Application for Amendment 1 to CoC 72-1027
for the
TN-68 Dry Storage Cask

Part B

Proposed Revision of the TN-68 Technical Specifications

TN-68 GENERIC TECHNICAL SPECIFICATIONS

Figure 2.1.1-1

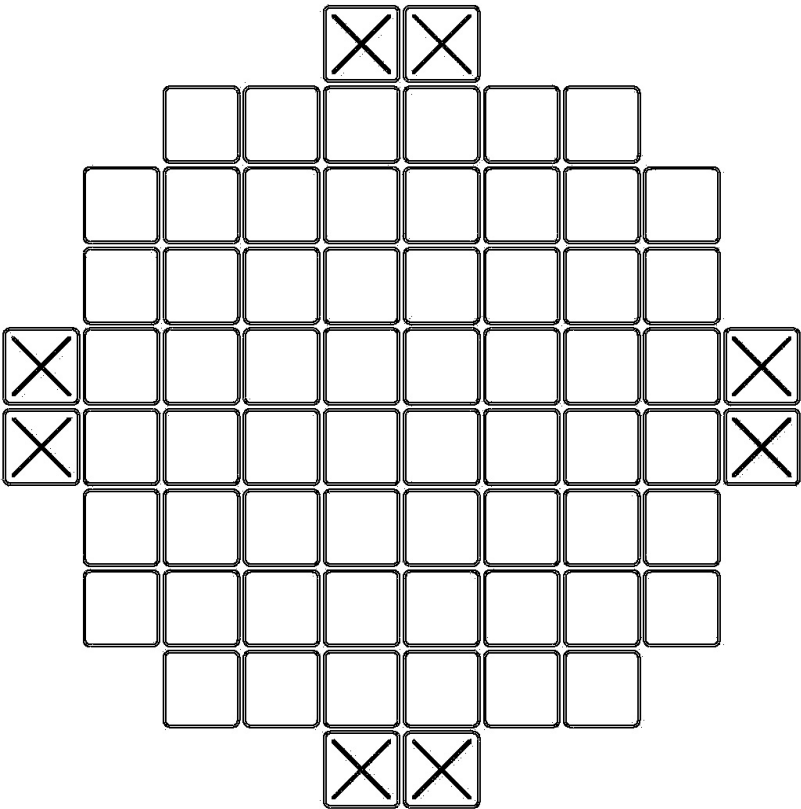
- A. Fuel shall be unconsolidated INTACT FUEL ASSEMBLIES *except that up to 8 fuel assemblies with damage consisting of*
 - i known or suspected cladding defects greater than pinholes or hairline cracks, or*
 - ii no more than one structurally damaged or missing grid spacer**may be stored subject to the following limitations:*
 - i they must be handled by normal means*
 - ii they must be stored in a basket configured for damaged fuel, in the designated compartments shown in Figure 2.1.1-1, with end caps installed top and bottom, and*
 - iii there must be no missing fuel pins or fuel pin segments.*
- C. Fuel shall be limited to fuel with Zircaloy cladding.
- D. Fuel shall be limited to the following fuel types *or equivalents by other manufacturers* with the following unirradiated specifications:

Damaged fuel is to be stored only in a basket configured with damaged fuel compartment extensions at the locations marked with an X.

Figure 2.1.1-2

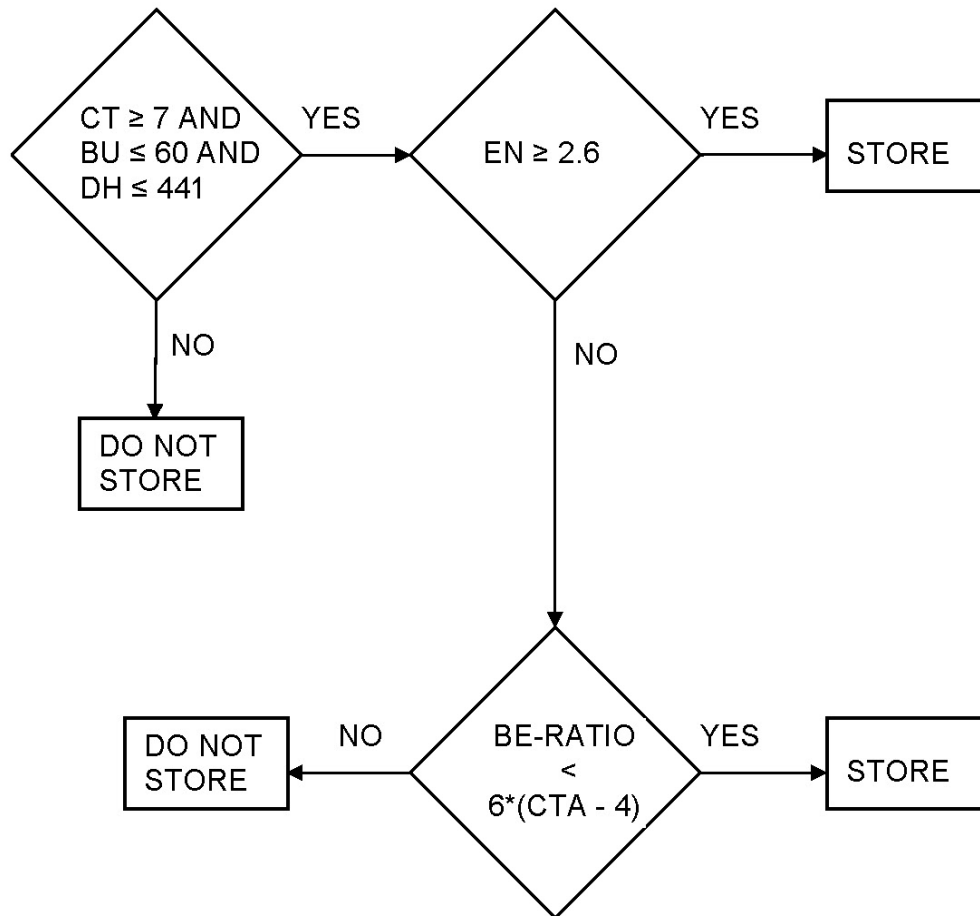
- F. 8x8, 9x9, and 10x10 fuel assemblies shall be selected using the flow chart in Figure 2.1.1-2.*
- G. All fuel assemblies shall have the following bounding characteristics:*
 - i. maximum initial enrichment *per Table 2.1.1-2*
 - ii The maximum weight per individual assembly shall be 705 pounds.
